TO: Planning Board
CC: Jeff Amos, Terradyn Consultants, Applicant's agent
FROM: Jason Garnham, City Planner
DATE: June 6, 2022
RE: Clover Leaf Development, 986-989 Portland Rd (Map 63 Lot 3-1): Site Plan, Conditional Use, & Final Subdivision Review

Saco Planning Board
DRAFT Findings of Fact
Clover Leaf Development, 986-989 Portland Rd (Map 63 Lot 3-1)
Site Plan Review
June 7, 2022

DATE: 4/4/2022
SCALE: 1"=120'
DESIGNED: JDA
JOB NO: 2104
FILE: 2104 B
SHEET C-1.0

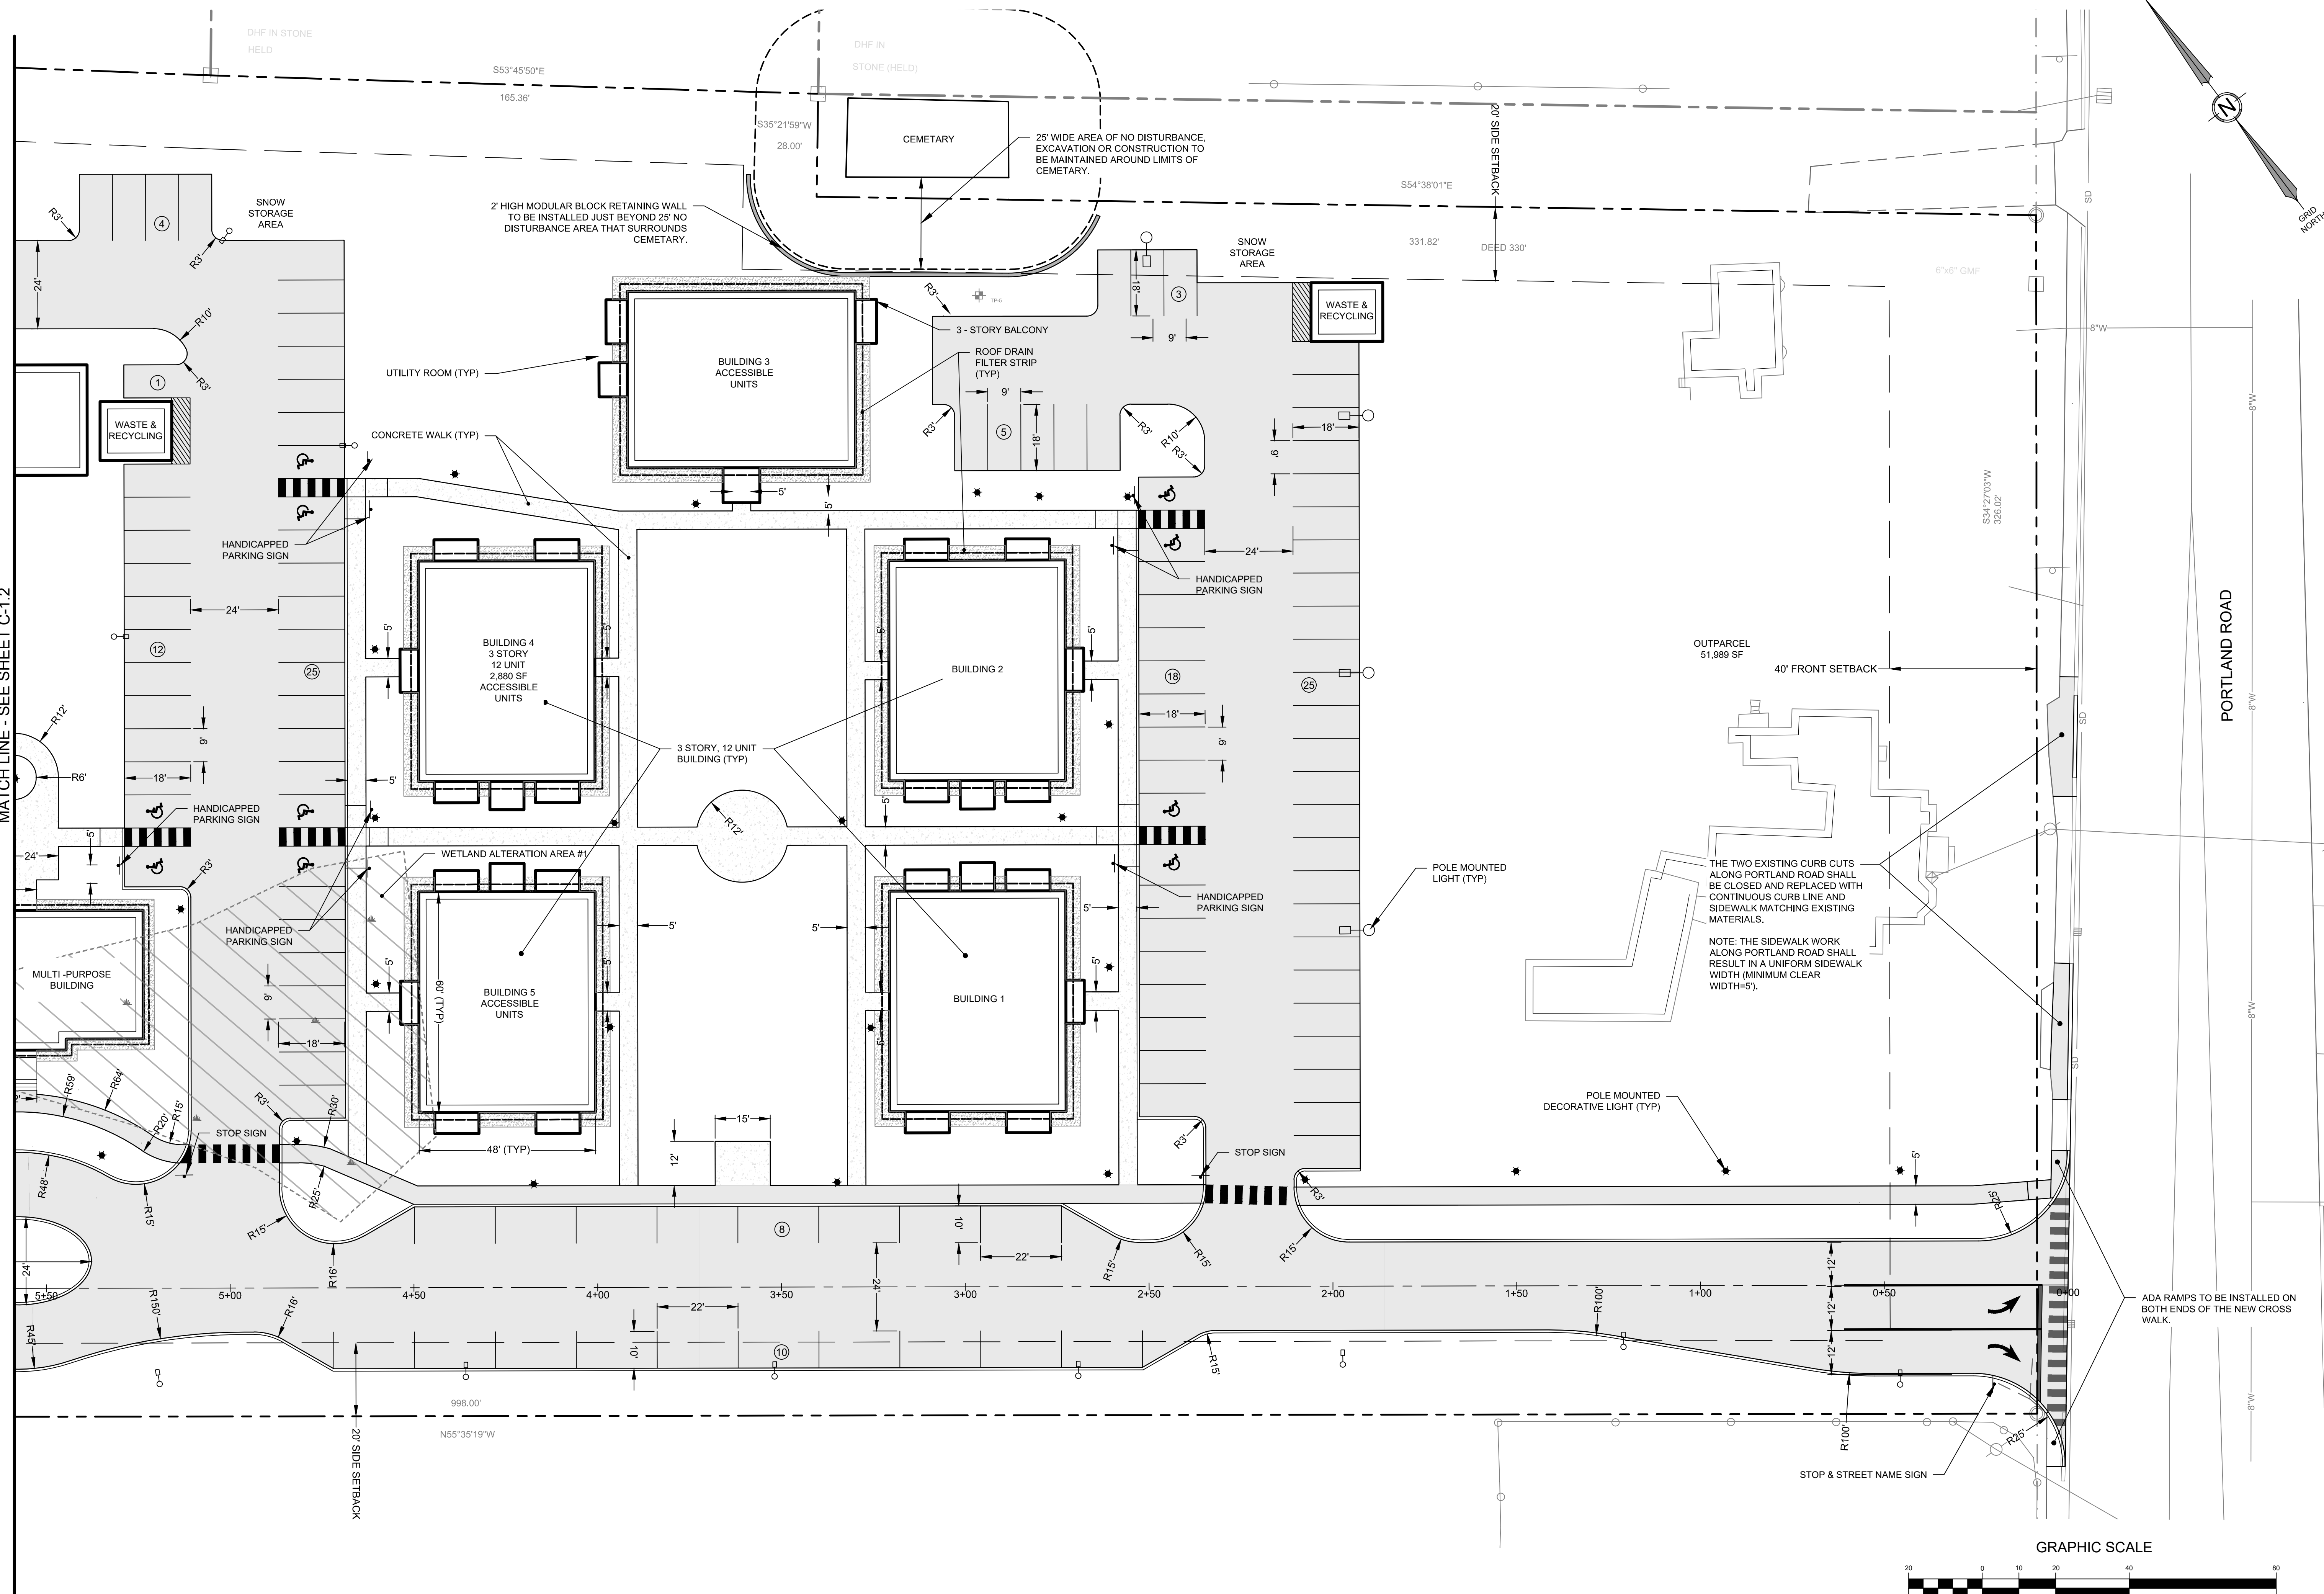
1. As a housekeeping matter on Sheet C-1.0, please confirm the total number of parking spaces (211 versus 210) and the required number of parking spaces for phase 1 one-bedroom units (84 versus 81) and total required phase 1 parking (106 versus 103).
2. As commented previously, the applicant should consult with the Saco Fire Department on the requirements and locations for onsite fire hydrants, knox boxes, annunciator panels, external sprinkler riser connections, fire lanes, etc. In addition, the Saco Fire Department should be consulted on the requirements for emergency vehicle access within the site and need to accommodate provisions to turn emergency equipment around within the site (including initial phase of development).

3. Provide turning movement diagrams for service vehicles accessing the site (i.e. solid waste disposal, deliveries, etc.).
4. Note 7 on Sheet C-1.0 should be revised to include the recently issued wetland permit approval order numbers.

1. The water distribution layout was modified to simplify the design. The units will be served from a main located in each respective courtyard. The changes were reviewed and approved by Maine Water.
2. A topographic survey was conducted in the area that will contain the stormwater pond & level spreader. The existing contours were updated to incorporate the updates. The LIDAR contours were fairly accurate, so the change is likely unnoticeable.
3. Sheet C-1.0 Overall Site Plan was modified with the addition of
 - a. bearings and distances on all exterior lot lines as well as the limits of the open space.
 - b. Note 14 was added that outlines the sunset provisions of Section 503 of the subdivision ordinance.
 - c. The conditions of approval notes were added to the plan.
 - d. Note 7 was updated with the approved permit application numbers.
